Interactive comment on “Hadley cell expansion in CMIP6 models” by Kevin M. Grise and Sean M. Davis

Kevin M. Grise and Sean M. Davis

Interactive comment on Atmos. Chem. Phys. Discuss., <https://doi.org/10.5194/acp-2019-1206>, 2020.

Fig. 1. Revised version of Figure 2

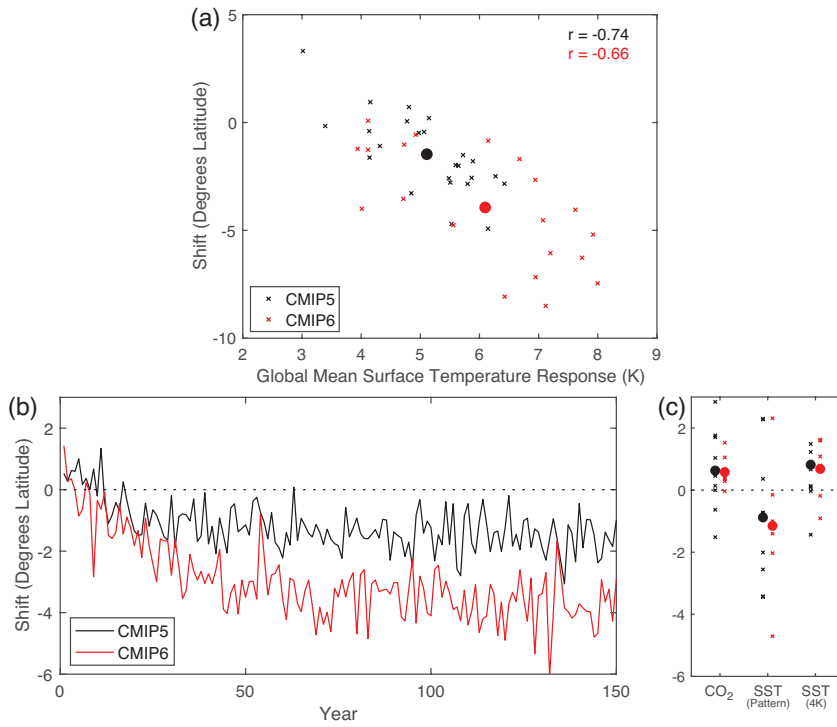
My comment is that the role of the pattern of SST warming for the NH JJA contraction should be discussed. For CMIP5 models, there are significant differences in Hadley cell edge response between the amipFuture and amip4K experiments for the NH JJA season. So it would be helpful if results from the amip4K experiment were shown for comparison. Furthermore, Zhou et al. (2019) argue that an ITCZ shift related to the pattern of enhanced equatorial SST warming drives the subtropical circulation contraction during NH JJA. This is different from the present manuscript, in which it is argued that a general SST warming (pattern not required) forces the equatorial contraction during summer.

As requested by the reviewer, we have added results from the amip4K experiments to Figure 2c (also to Figure S2b). Please see the attached revised version of Figure 2. The reviewer is correct that the sign of the NH Hadley cell edge response changes when the uniform 4K SST warming is used instead of the patterned 4K SST warming. To clarify this, we have added the following text:

“However, as pointed out by Zhou et al. (2019), the exact pattern of SST warming is critical for capturing the equatorward contraction of the NH JJA Hadley cell edge seen in the abrupt 4xCO₂ runs. A uniform 4K SST warming would instead result in a poleward expansion of the NH JJA Hadley circulation (Fig. 2c).”
